TECHNICAL BULLETIN

Mounting Bolts for Manitou Direct Mount Disc Brake

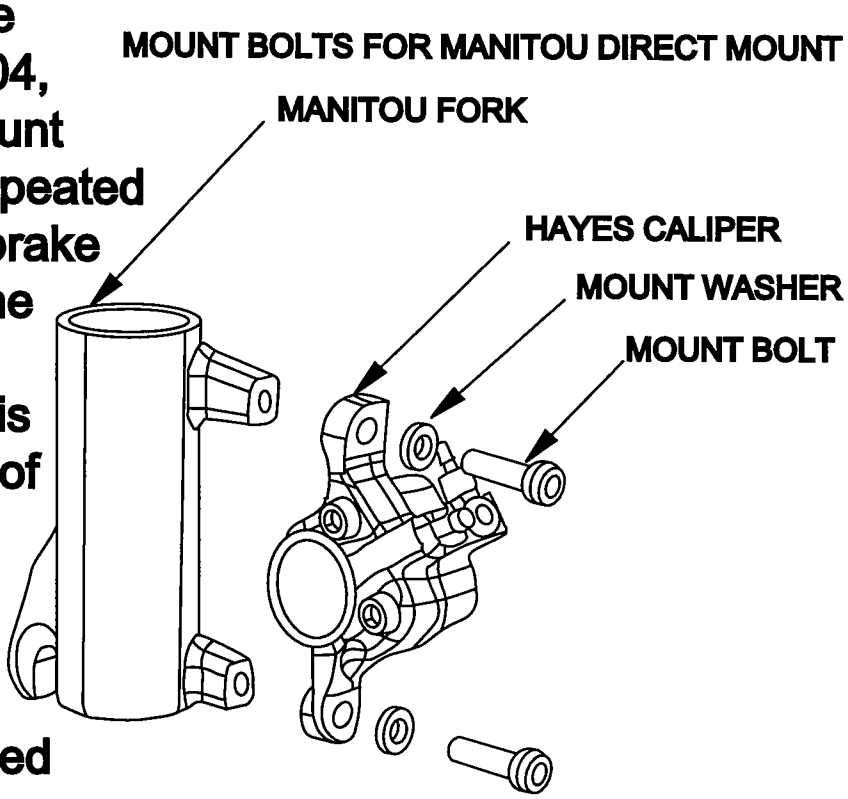
Hayes Brakes has updated the mounting bolt standard for 2004, this affects bikes with post mount or Manitou type forks. With repeated removal or adjustment of the brake caliper the threaded post on the fork leg can become worn or damaged. The new standard is an increase in the total length of the mounting bolt. The longer bolt will reduce wear and tear on the threaded post of the fork leg. For this reason we ask that you replace the affected models with the new hardware provided by Hayes and follow the torque spec as indicated. To have new hardware sent to you at no cost contact ***Hayes Disc Brake at 1-888-686-3472. www.hayesdiscbrake.com***

TORQUE MOUNT BOLTS TO
80 + OR - 5 IN-LBS.
